802.3dj D2.2

Comment Resolution

Logic Track

Figure 184-10—Deskew state diagram

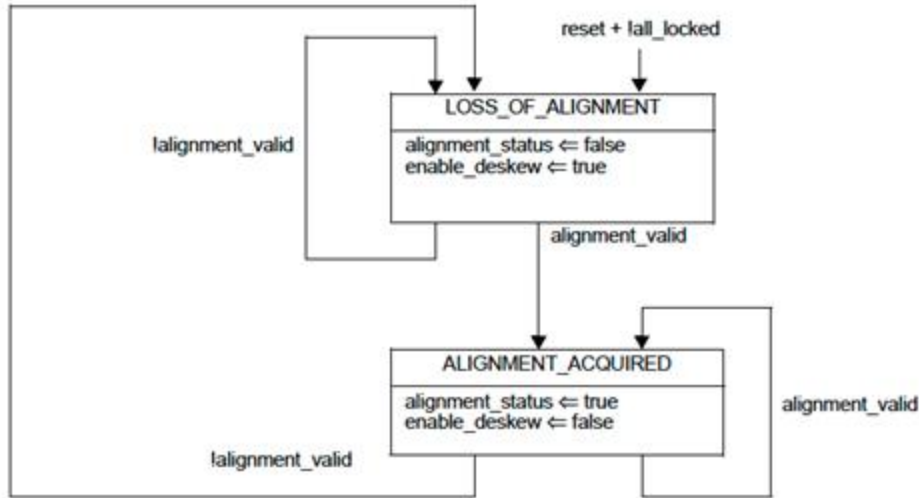
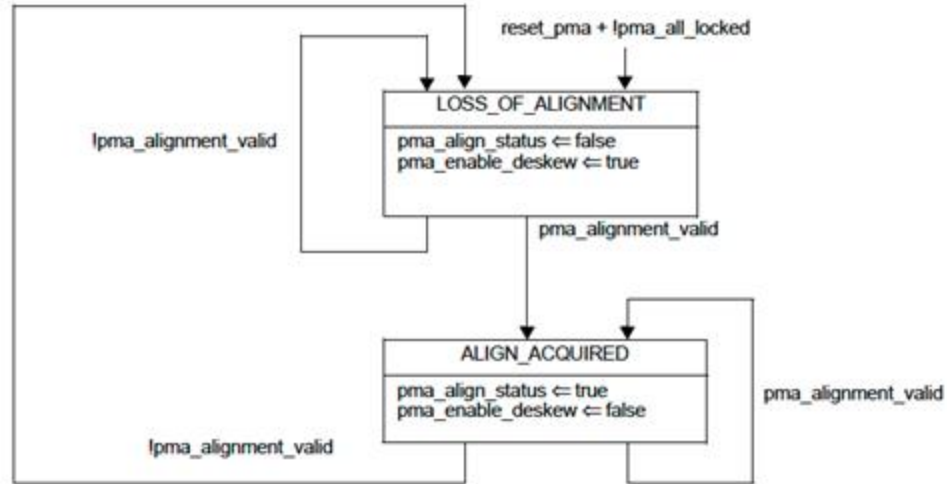
- In both state diagrams the value of `alignment_status` / `pma_align_status` is exactly the same as `alignment_valid` / `pma_alignment_valid`. The `[pma_]alignment_valid` variables have “complete” definitions, making the “status” variables unnecessary.
- The `enable_deskew` variables are set but never used.
- Both state machines do not add information in a meaningful way and can be removed.

- Remove Figure 184-10 and all references to it.
- In 184.7.3:

- Remove Figure 186-18 and all references to it.
- In 186.4.3:
 - ~~The 800GBASE-ER1 PMA shall also implement the deskew process as shown in Figure 186-18.~~
- Delete unused variables in 186.4.2.1 variable definitions:
 - pma_align_status
 - pma_all_locked
 - pma_enable_deskew
- Update text in 186.3.4.3 to clarify the deskew process.

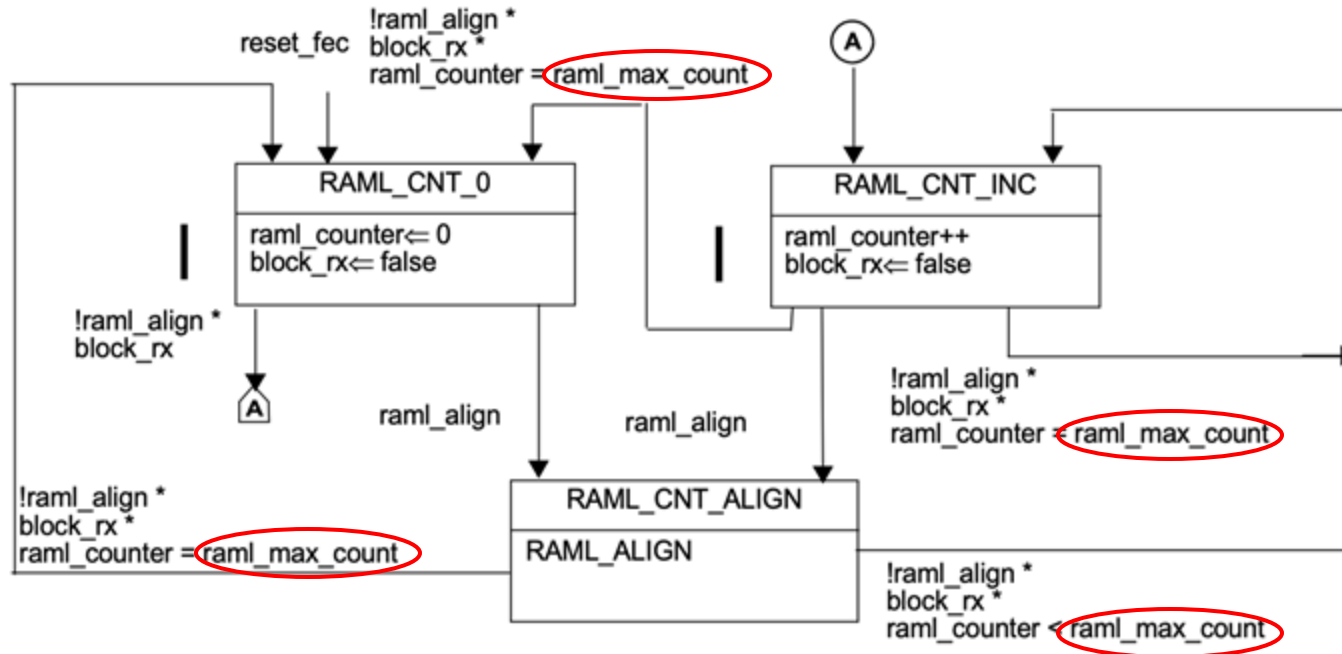
Cl 186	SC 186.4.2.1	P677	L51	# 379
Opsasnick, Eugene		Broadcom		
Comment Type	TR	Comment Status	D	ER1 state diagrams (L)
The definition of raml_max_count says it indicates a number of 257-bit blocks between alignment markers. This variable is used in state diagram figure 186-21 in comparisons to raml_counter, but it is never set to any value in any of the state diagrams or in text. How is its value actually set?				
Suggested Remedy				
If the value of this variable is supposed to be the number 257-bits between alignment markers as they are inserted by the 800GBASE-R PCS, then add to the definition that the value equals the 800G AM interval of 16k cw * 20 block/cw = 327,680. This number includes the AMs, but if raml_max_count is supposed to be only the number blocks "between" the AMs, not including the AMs, then subtract 16 from this number.				
Proposed Response		Response Status W		
PROPOSED ACCEPT IN PRINCIPLE.

Since the spacing between AMs is fixed, raml_max_count should be defined as a constant rather than a variable. Remove the definition of raml_max_count from subclause 186.4.2.1. Add a new subclause for Constants (which will become the new 186.4.2.1) and define RAML_MAX_COUNT as a constant value in that subclause. The intent is to represent the interval between the first block of consecutive AM groups in the original block stream. Since AMs are removed, the value won't include the size of the AM block, so it would be 327664. Update the 800GBASE-ER1 FEC sublayer alignment marker location state diagram to replace raml_max_count with the newly defined constant.

- Step 2: Replace the variable raml_max_count with the constant RAML_MAX_COUNT in Figure. 186-21.

Figure 186-19—800GBASE-ER1 FEC sublayer FAM field lock state diagram

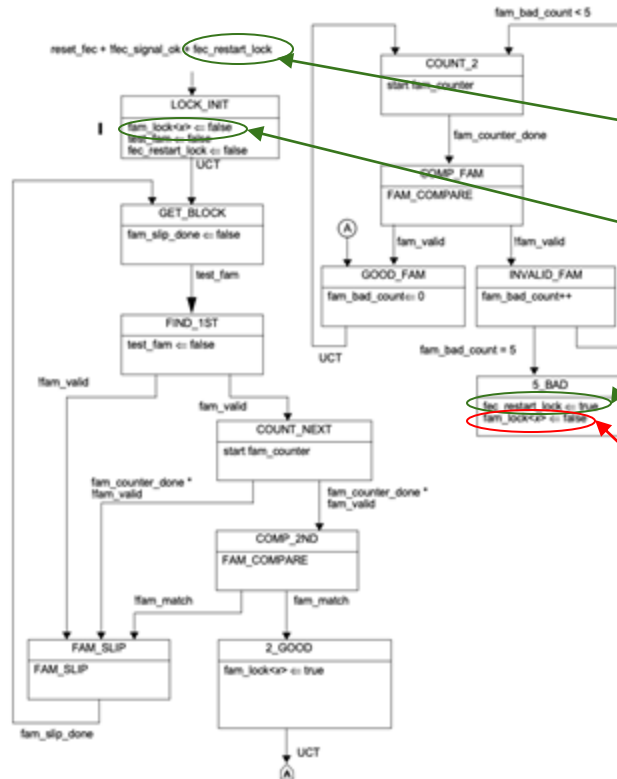
In 5_BAD state of state diagram 186-19, the assignment "fam_lock<x> <= false" is redundant with the same assignment in state LOCK_INIT, and should be removed. Setting fec_restart_lock to true will restart all 8 instances of the 186-19 state diagram (x=0 to 7), and they will all go to LOCK_INIT state and each one will set it's fam_lock<x> to false. Having the redundant assignment in 5_BAD seems to imply that just the single instance is being reset, but if that were the case then fec_restart_lock should also be indexed with <x> for each instance of the state diagram.

(1) Setting fec_restart_lock to true in 5_BAD state causes all 8 instances of this state diagram to restart the lock process.

(2) Each of the 8 instances resets fam_lock<x> to false in the LOCK_INIT state

Setting fam_lock<x> to false in the 5_BAD state is redundant and a little misleading.

In 5_BAD state of state diagram Fig. 186-19, remove the assignment of fam_lock<x> to false, and leave only the assignment of fec_restart_lock to true.

Update the 5_BAD state in Figure 186-19 and the 15_BAD state in Figure 186-17 per the suggested remedy.

Remove this line from 5_BAD.

Figure 186-17—800GBASE-ER1 PMA FAW field lock state diagram

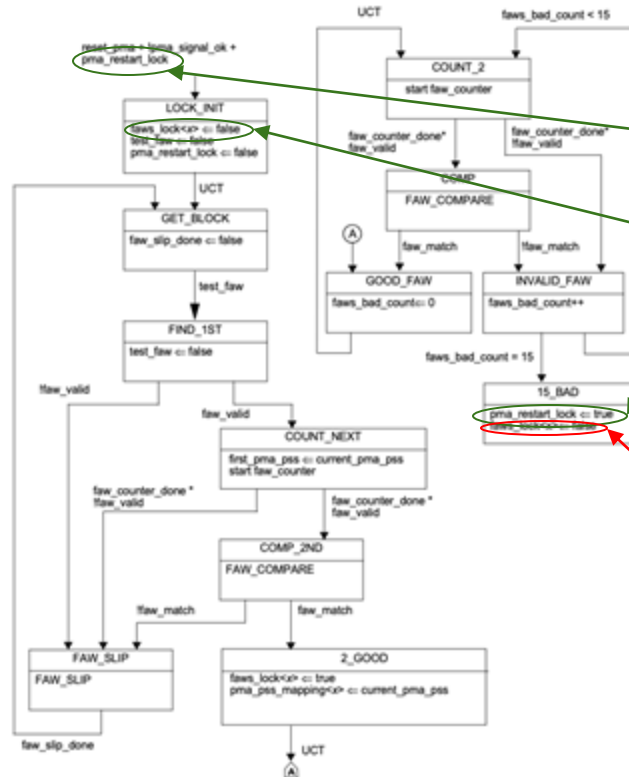
Similarly, in the state diagram in Figure 186-17, the assignment of faws_lock<x> to false in state 15_BAD should be removed.

(1) Setting pma_restart_lock to true in 15_BAD state causes all 8 instances of this state diagram to restart the lock process.

(2) Each of the 8 instances resets faws_lock<x> to false in the LOCK_INIT state

Setting faws_lock<x> to false in the 15_BAD state is redundant and a little misleading.

Remove this line from 15_BAD.

Figure 186-20—800GBASE-ER1 FEC sublayer multi-frame alignment state diagram

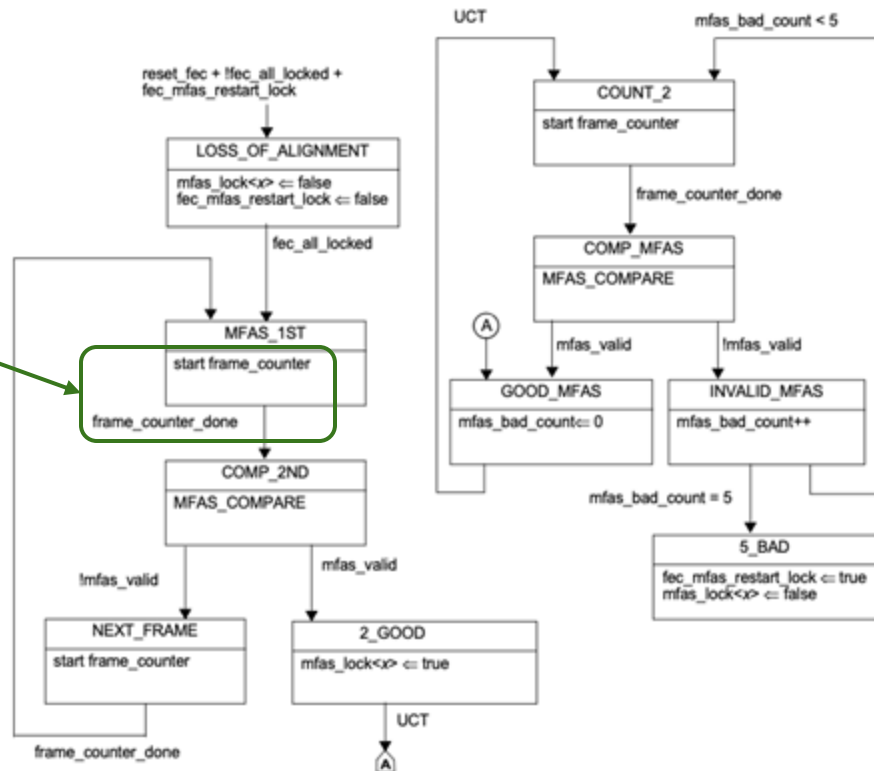
The variable frame_counter appears in the state diagrams in figures 186-20 and 186-21, but the counter that is required is different in each diagram:

There are 8 instances of the Fig. 186-20 state diagram process.

Each instance has a “frame_counter<x>”

Comment #385 will update “frame_counter” to “frame_counter<x>” in this state diagram.

Figure 186-21—800GBASE-ER1 FEC sublayer alignment marker location state diagram

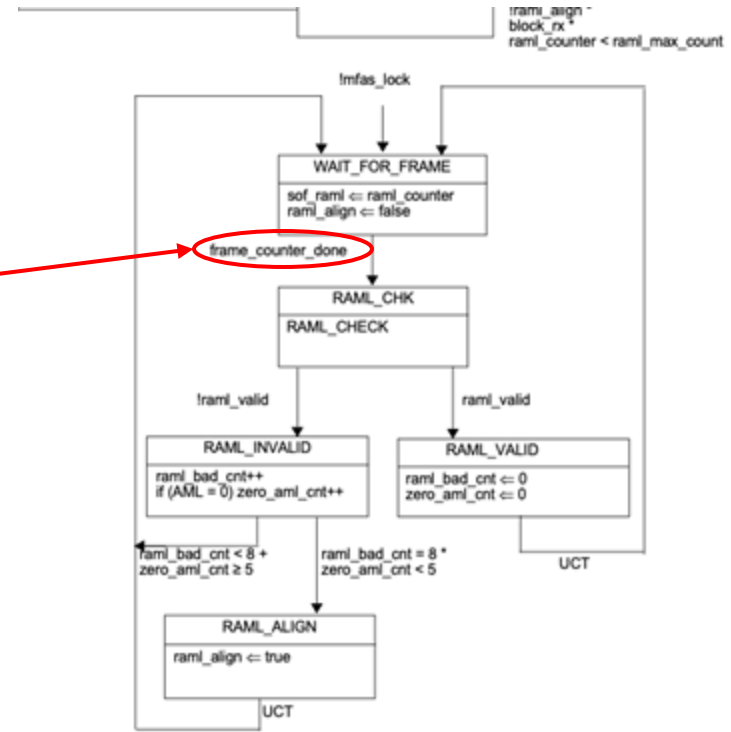
CI 186	SC 186.4.3	P 685	L 26	# 390
Opsasnick, Eugene		Broadcom		
Comment Type	T	Comment Status	X	
In the state diagram in Figure 186-21, the transition from state WAIT_FOR_FRAME to RAML_CHK is made when frame_counter_done is true. However, this counter is started in a different state diagram and it is very hard to tell how this is working since there are 8 instances of that other state diagram. It would be easier to follow if there were a separate counter for this state diagram that is started locally, and then wait for done and then reset the done variable in the next state.				
Suggested Remedy				
Add a new frame_counter with a unique name for use in the FEC sublayer alignment marker location state diagram.				
Proposed Response		Response Status O

Change frame_counter_done to multiframe_count_done.

Add new counter multiframe_counter (with editorial license).

Figure 177-n—PRBS13 scrambler

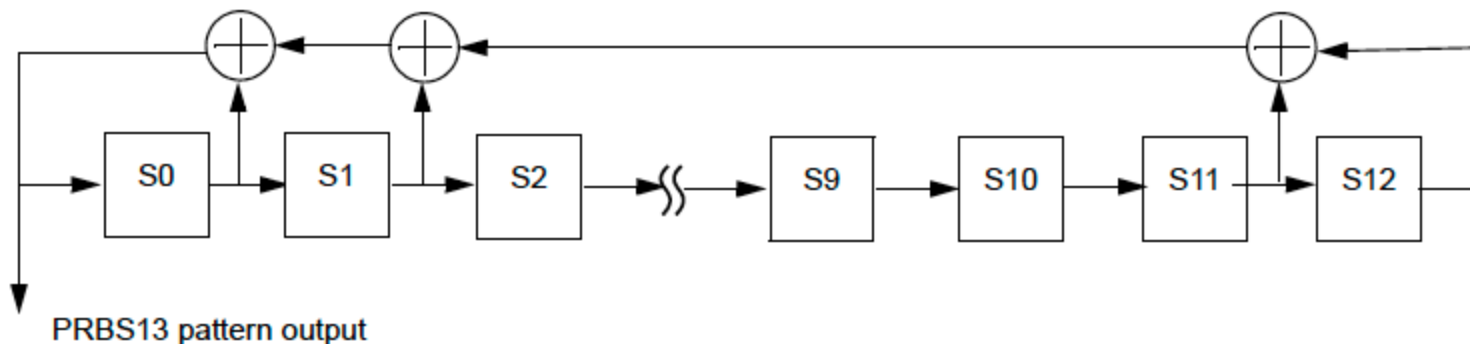
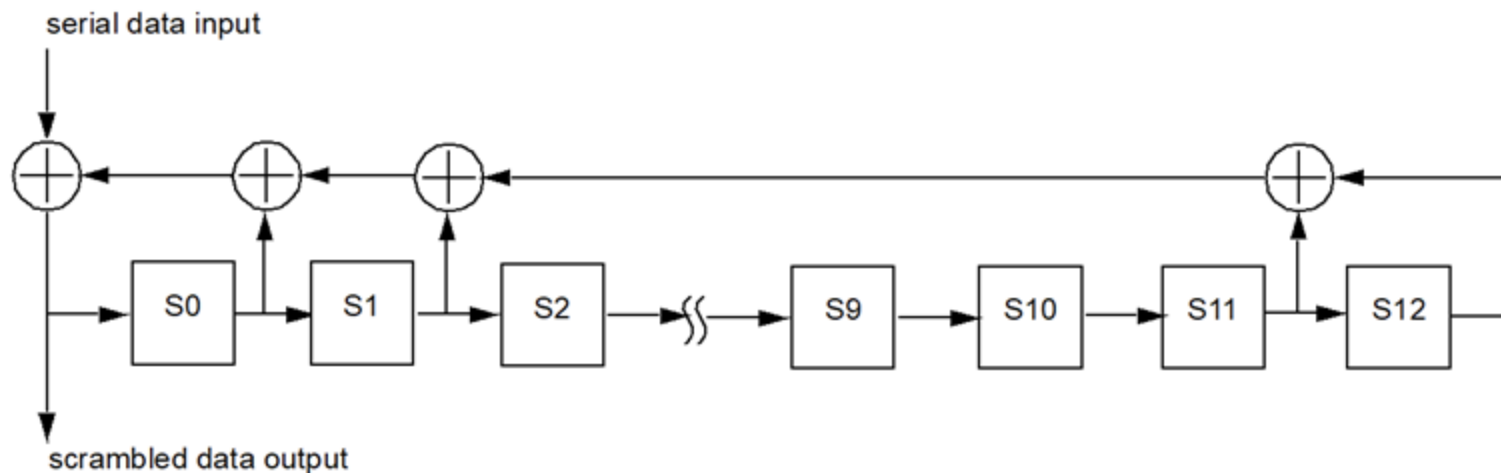
- 177.4.7.2 defines a 13-bit scrambler with a reference to Figure 94-6 and Equation 94-3.

- Figure 94-6 is a PRBS13 generator, and needs to be modified slightly to be a self-sync scrambler

- Add a new figure to 177.4.7.2, based on Figure 94-6, but adding the data input.

Figure 175-8—PCS synchronization state diagram

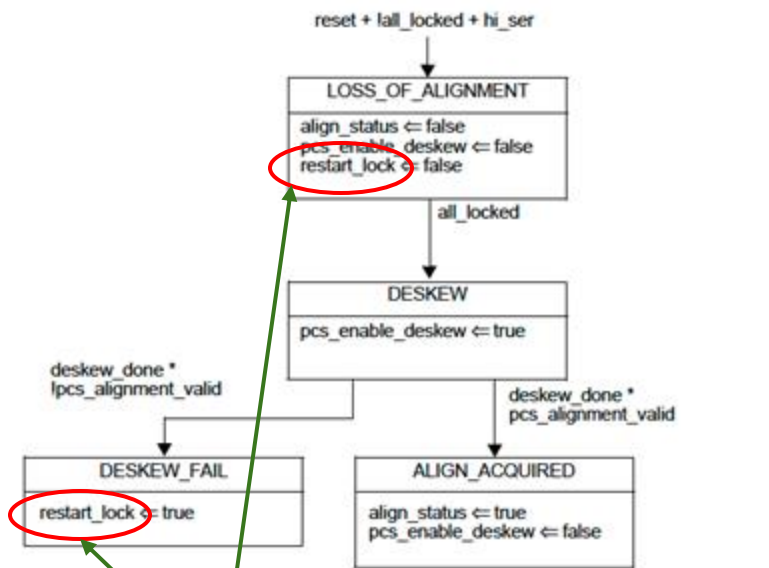
1. Two separate variables with same basic name (one is indexed) should be renamed to remove any confusion between them.
2. `Restart_lock` can be set to true by both a state diagram and by its own definition when another variable (`restart_lock<z>`) is set to true in a different state diagram.

Change to “deskew_failed”

Boolean variable that indicates the pcs synchronization process failed to identify 16 unique PCS lanes and is used to set the `restart_lock` variable. The value of `deskew_failed` is set by the PCS synchronization state diagram (Figure 175–8).
